# Zoning Staff Report

**Case Number:** ZC-21-191

## Zoning Map Amendment & Site Plan

**Site Location:** 840 & 1000 Oak Grove Road

A1.0  
SITE PLAN

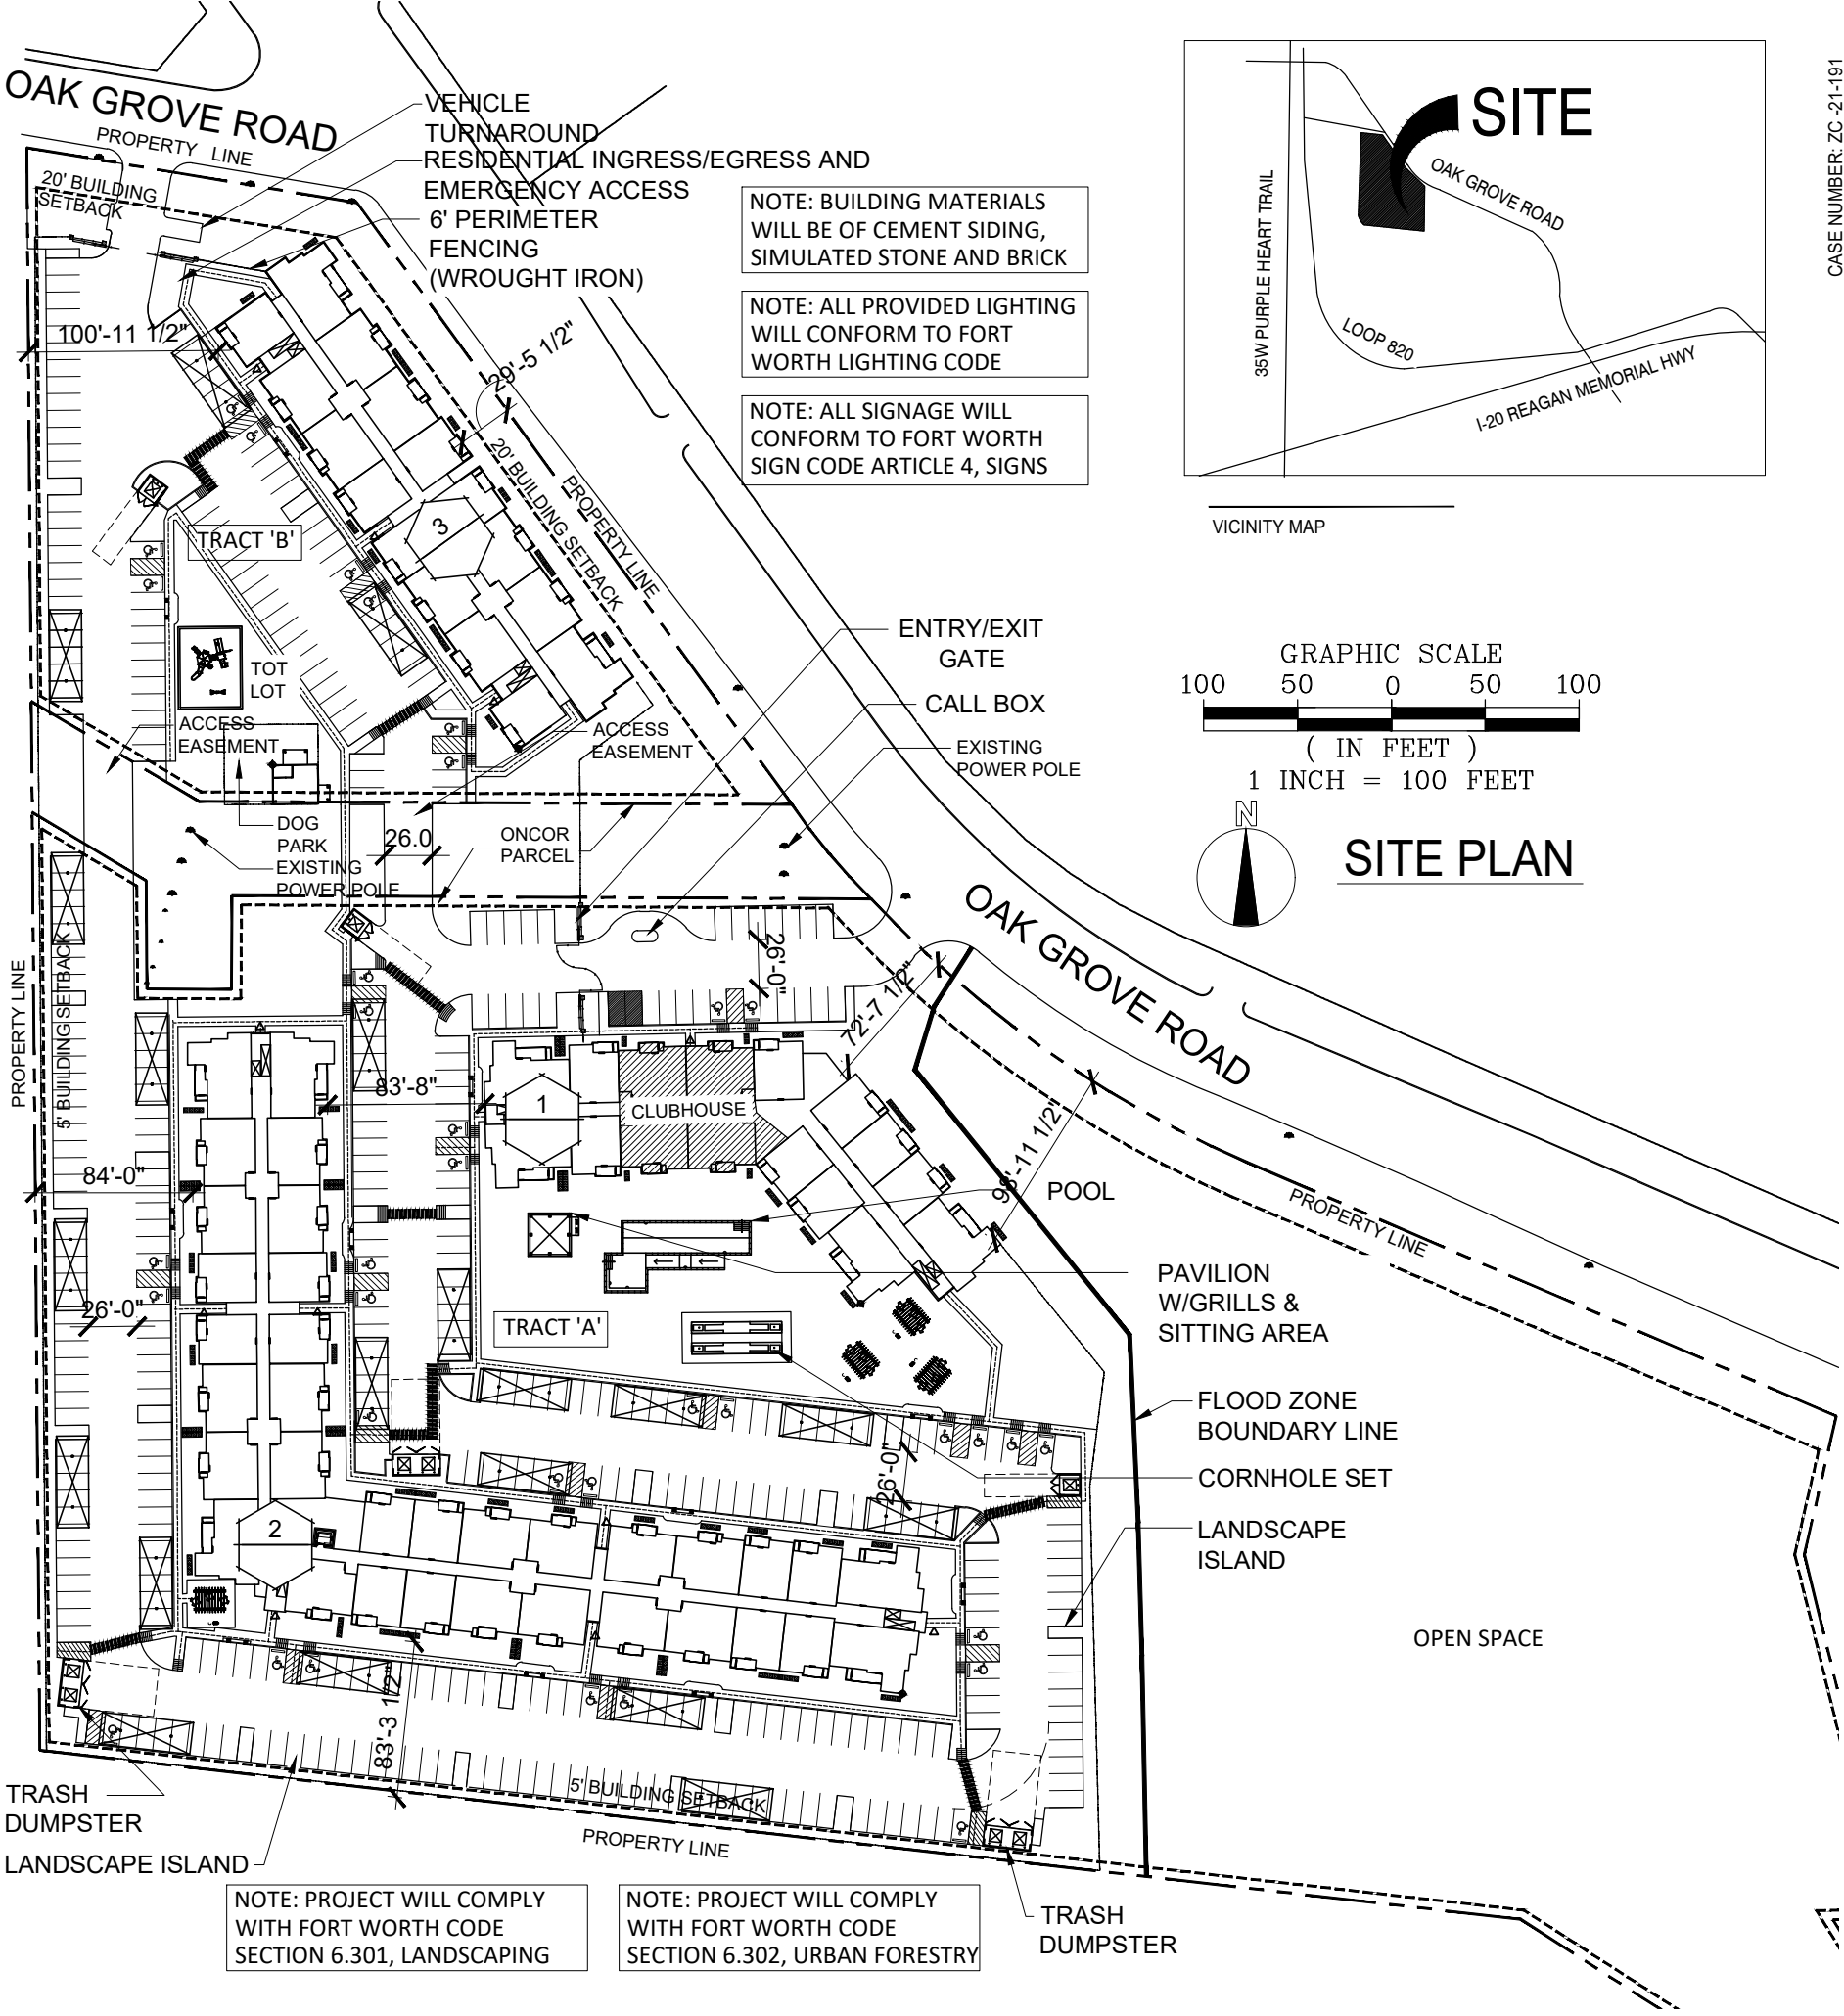
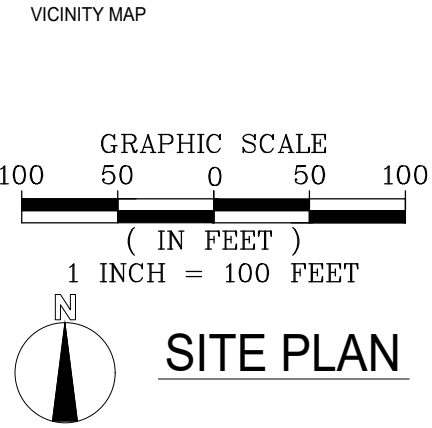
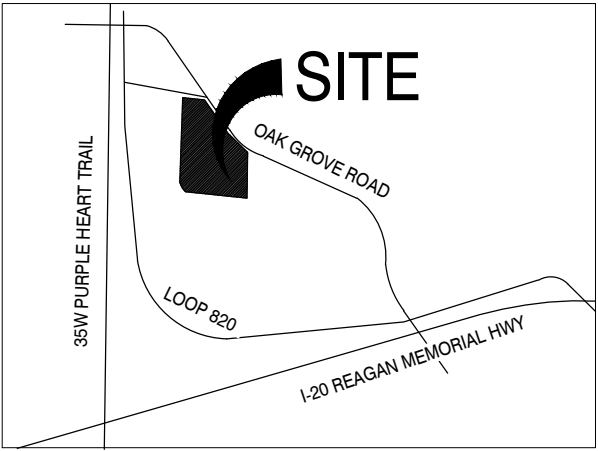
- The Site Plan as submitted shows 406 parking spaces provided, and 444 parking spaces required. This would leave the proposal short by 38 total parking spaces.

- Staff does not support a variance to the parking standards.
  - The area currently is not very accommodating of pedestrians (Walk Score is 37 out of 100)

- The area currently is not very accommodating of bicycles (Bike Score is 37 out of 100)
  - Trinity Metro bus route #33 is a feeder route with low frequency (one bus every 60 minutes)

- The nearest bus stop is not directly adjacent to the property
  - The parking requirements do not specifically account for visitor parking
  - No tuck under garage parking or podium parking is provided

- There is no on-street parking along Oak Grove (minor arterial street per MTP) as an alternative
  - Potential for overflow parking on street, off-site, and potentially into the neighborhood to the north

- If anything the parking spaces should exceed the minimum dimension of 9’x 18’ in order to accommodate standard vehicles commonly driven in Texas (i.e. oversized trucks and SUV’s).

- Planned Development “PD” zoning is not intended to be used as an end run around the Zoning Ordinance requirements or to bypass the Board of Adjustment. PD’s are intended to permit new or innovative concepts in land utilization not permitted by other zoning districts in the Ordinance.

- Pursuing standard “D” zoning without any waivers is a more appropriate and better in line with the spirit and intent of the adopted City policies.
- There is an example of a successful apartment project nearby at 1021 Oak Grove Road which was built in 2010 under the standard “C” zoning district requirements without a Planned Development or waivers.
